CONTRACT 1725

**CIPP REHABILITATION OF THE
LOWER SAW MILL RUN INTERCEPTOR**

ADDENDUM NO. 2

GATE CHAMBER
UPPER PLAN A
SCALE: 3/8" = 1'-0"

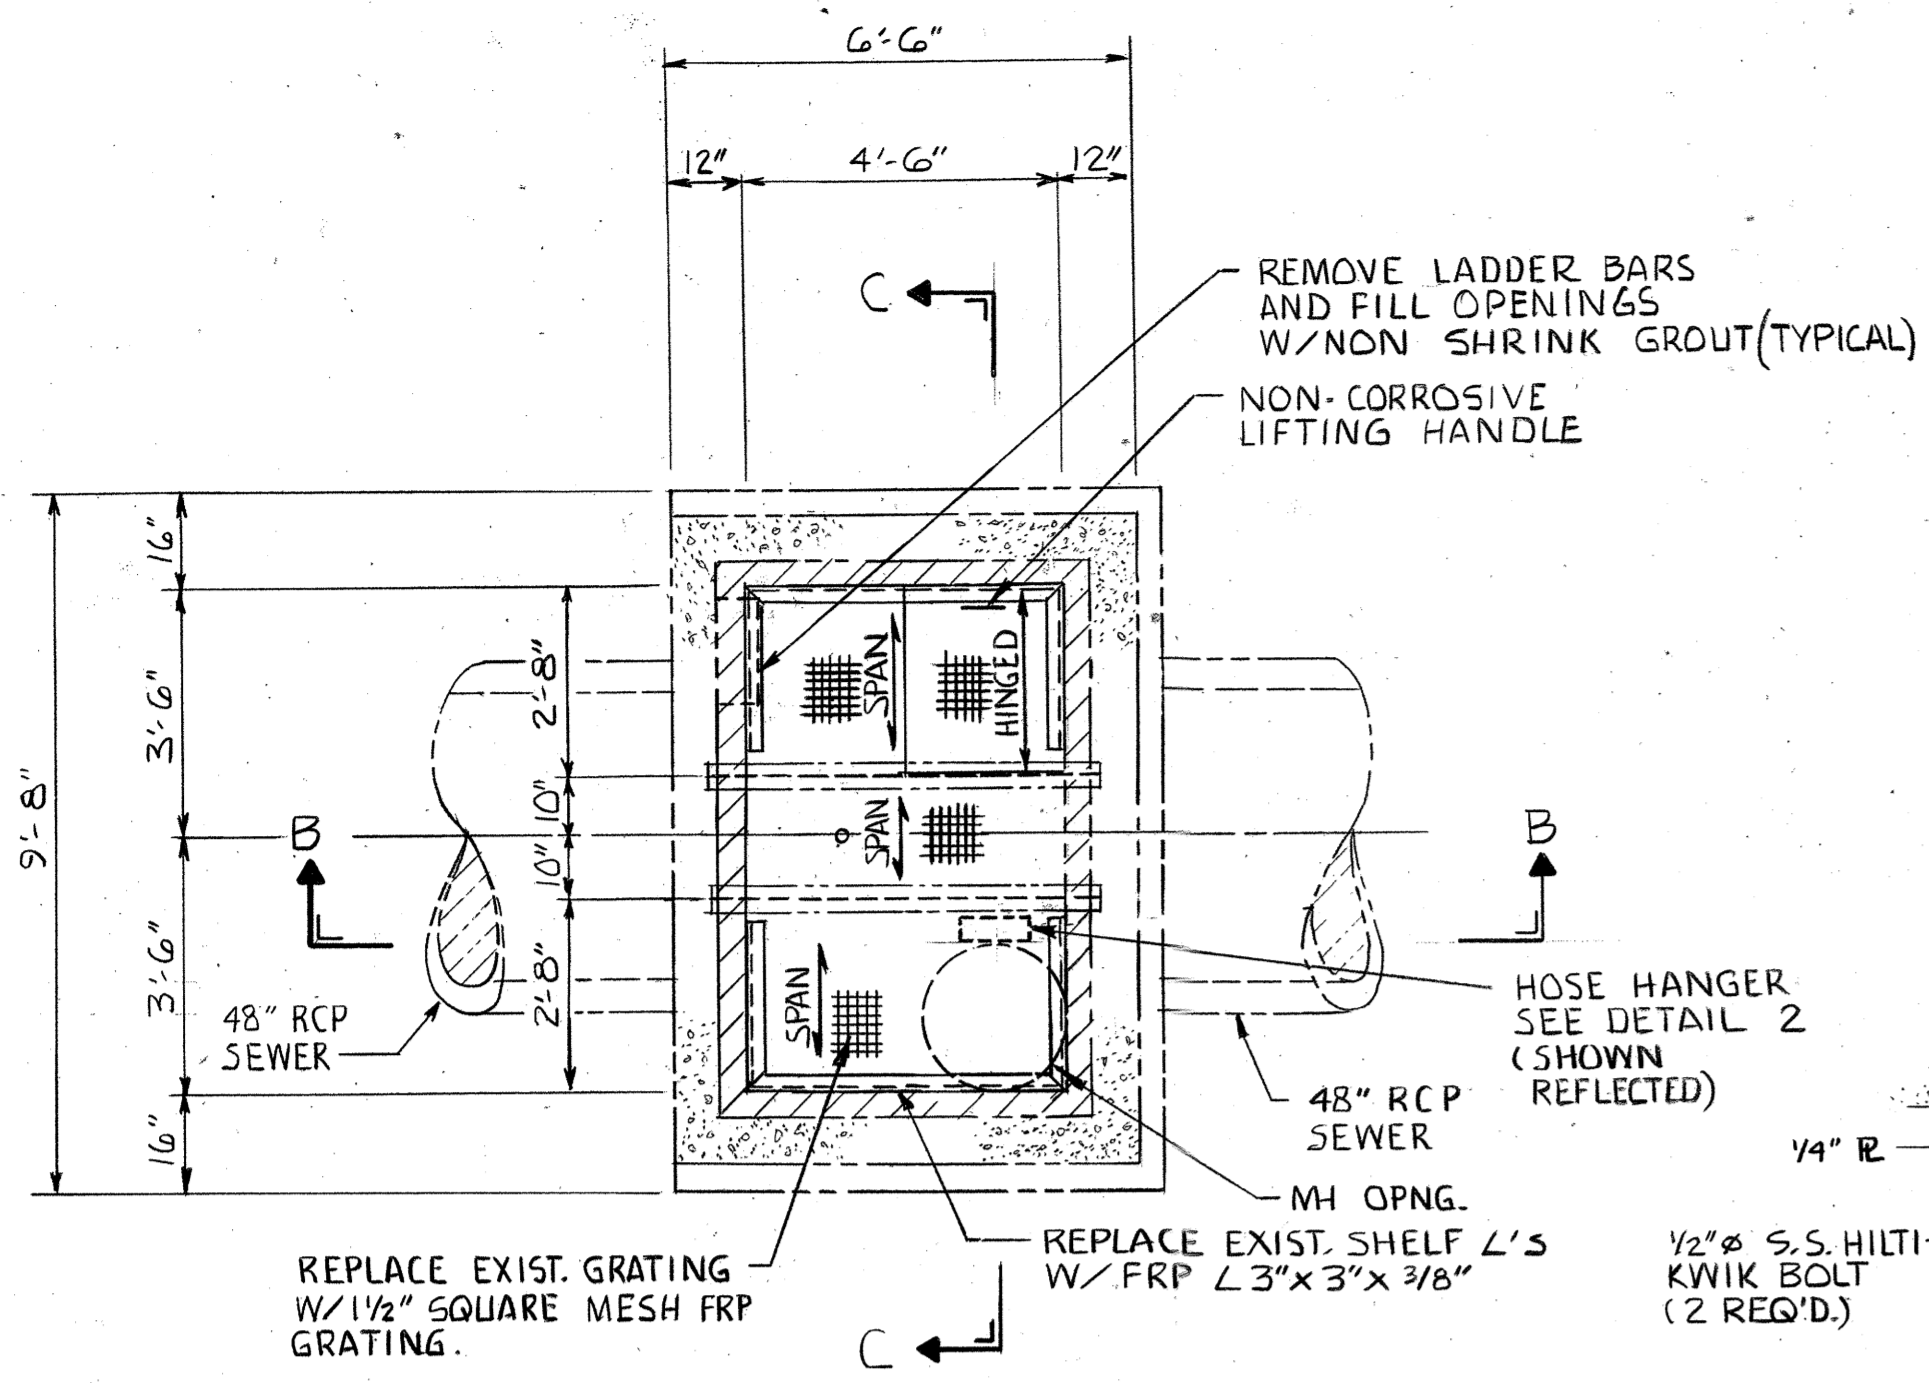
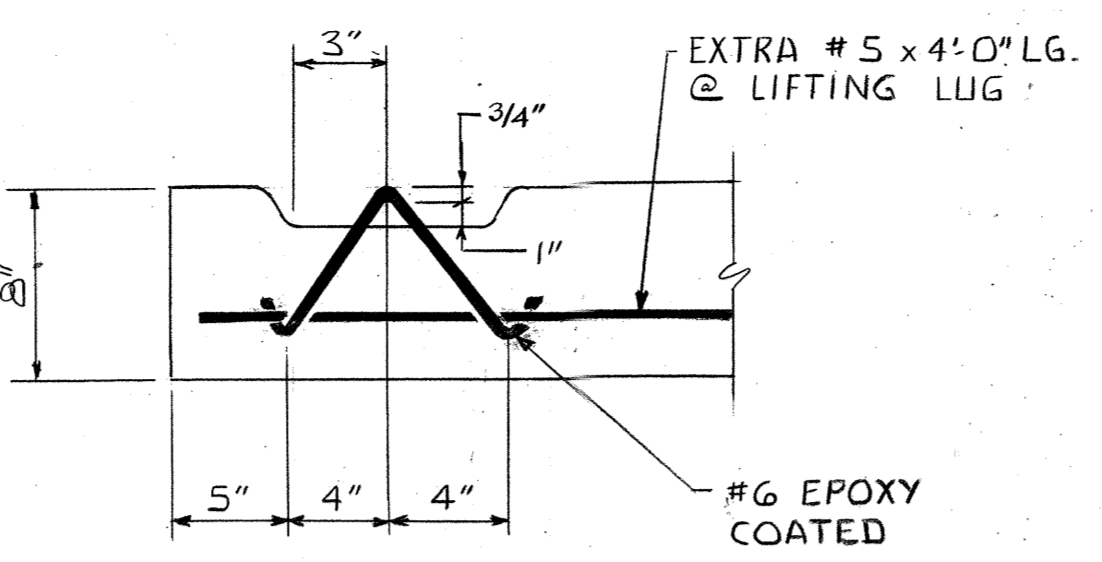
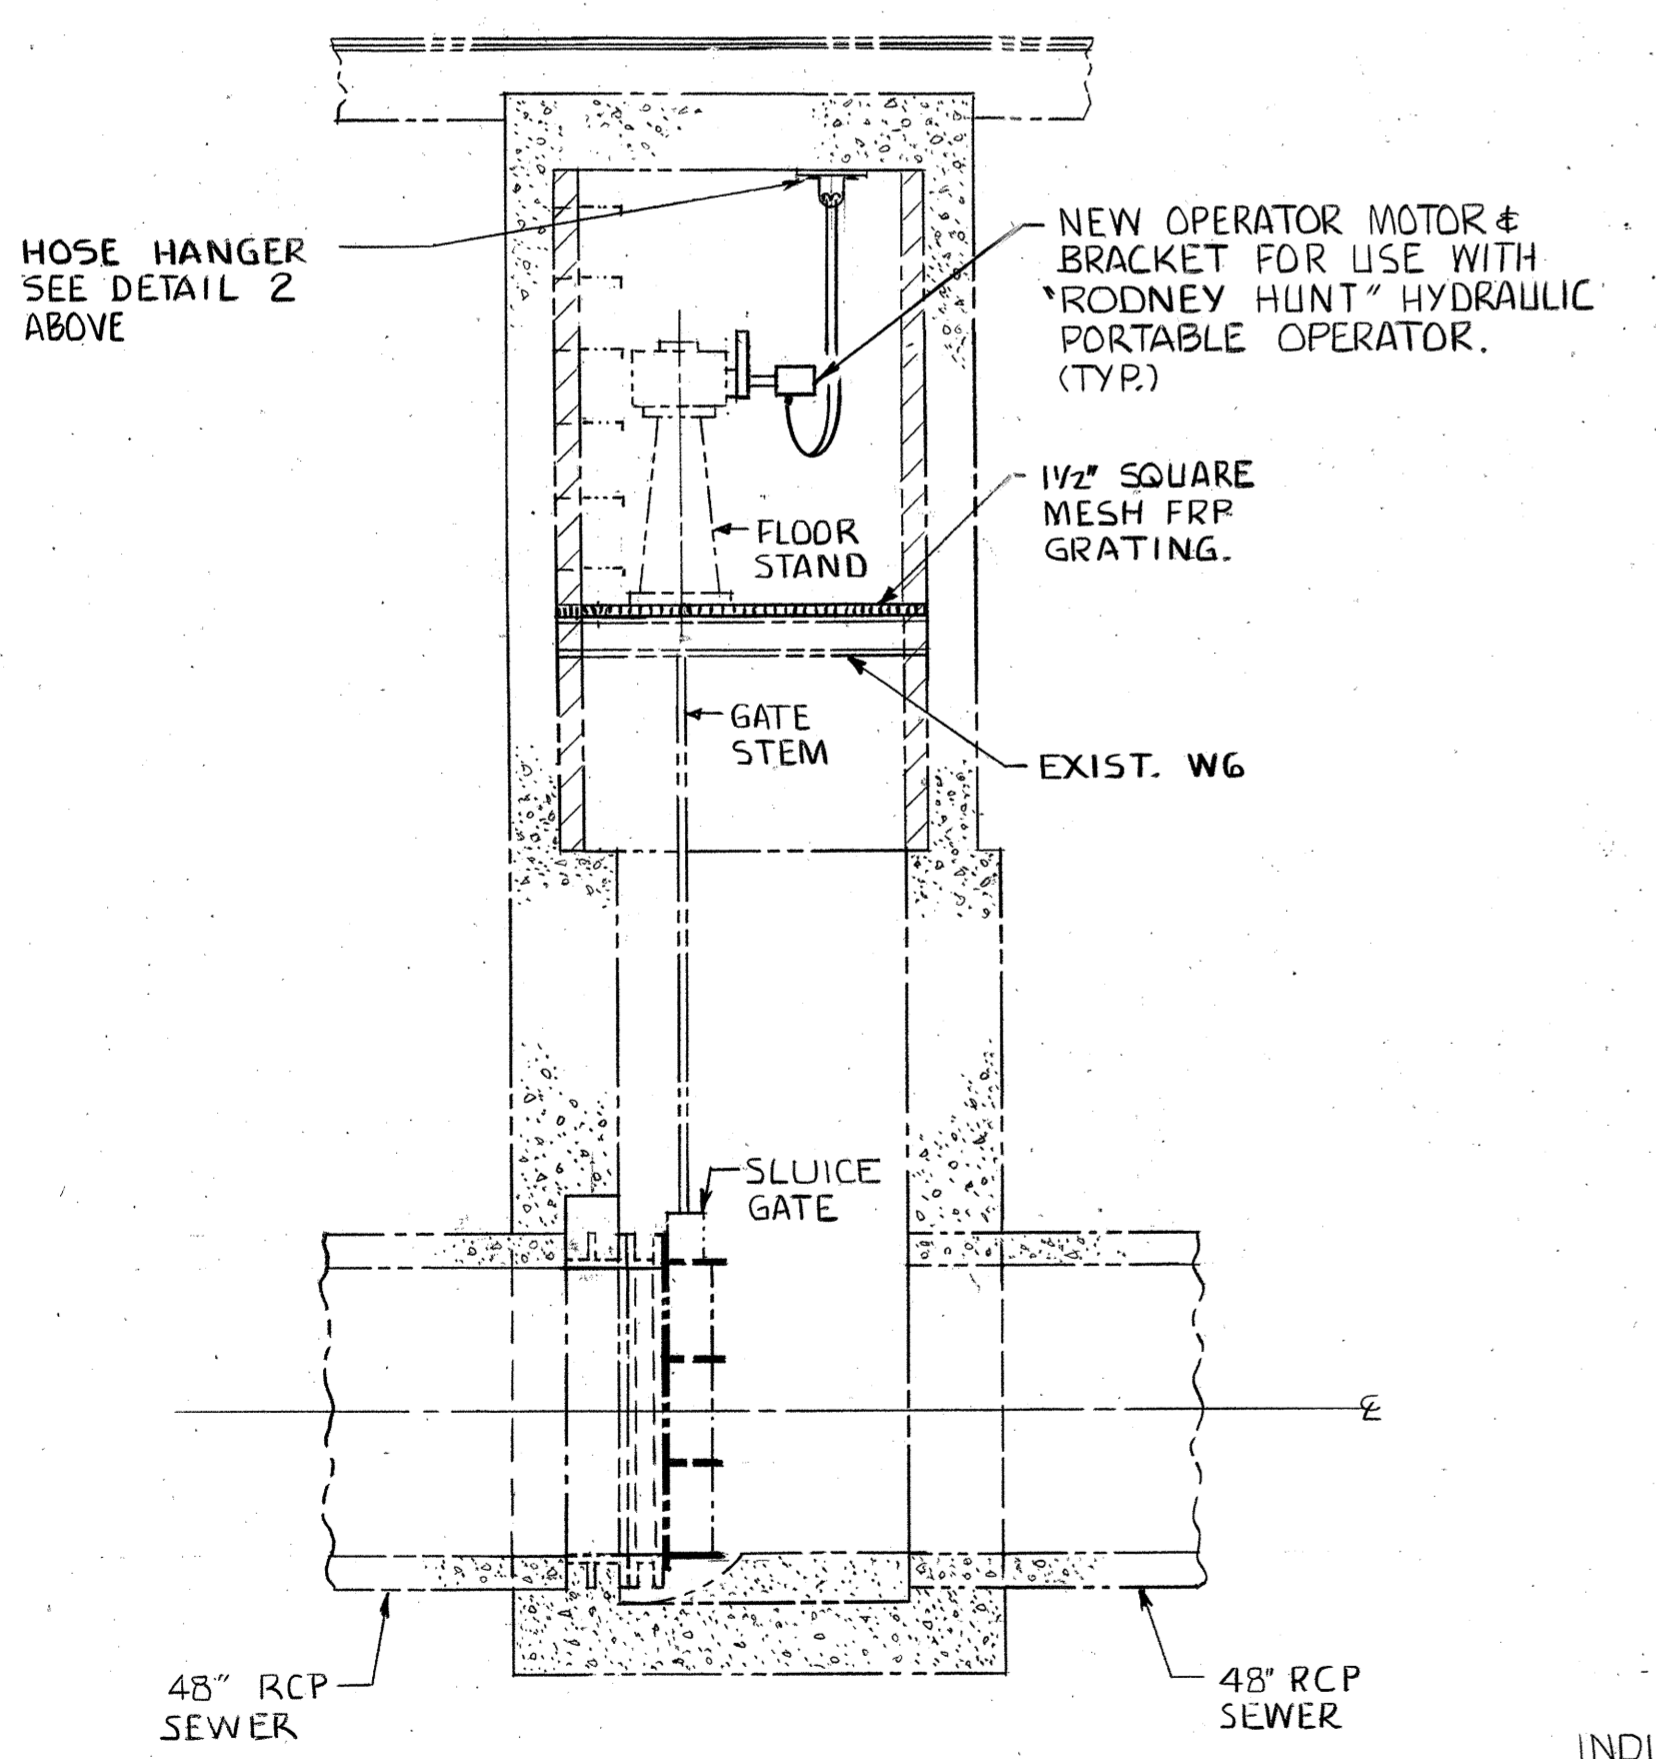
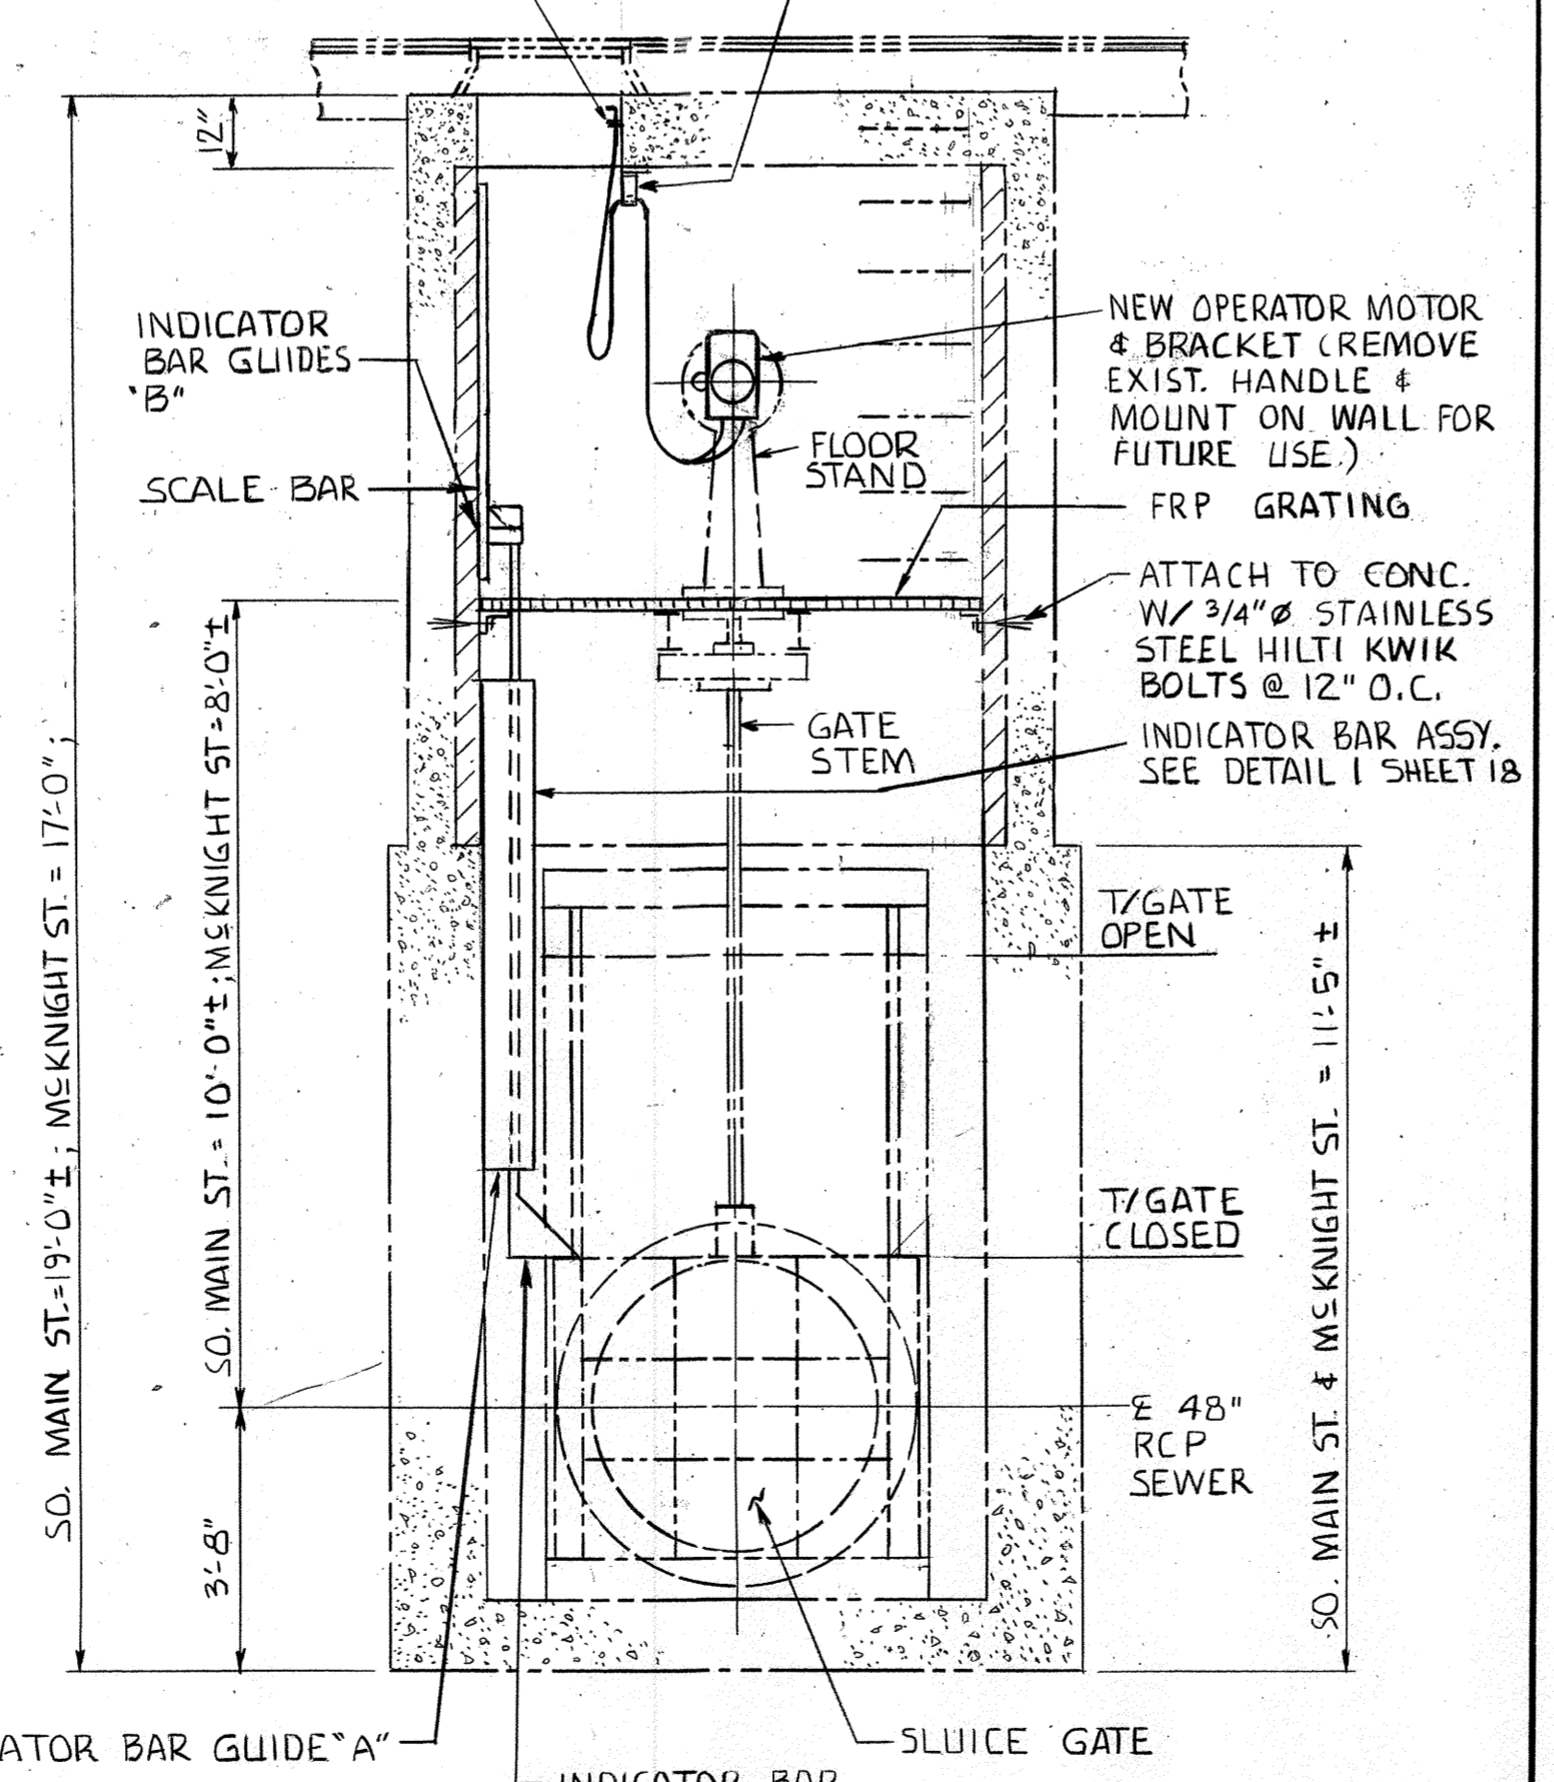
- 11.) Question: Sheet 23, Note 3 – can drawings, profiles showing size and weight of the grating, sluice gate and concrete roof be provided.

- 38.) Question: Spec. discusses potential rehabilitation to MH S-02A-00. Will the Owner provide a section detail of this manhole? Will the Owner add a bid item for this specific work?

Answer: ALCOSAN does not possess information regarding the weight of these items. Contract 940 Sheet 17 is included as an attachment with this Addendum for information only.

Answer: Rehabilitation work includes CIPP lining of incoming and outgoing interceptor pipes, paid for under Bid Item 4, and epoxy coating the interior of the concrete chamber, paid for under Bid Item 7. See attached Contract 940 Sheet 17 for additional information.
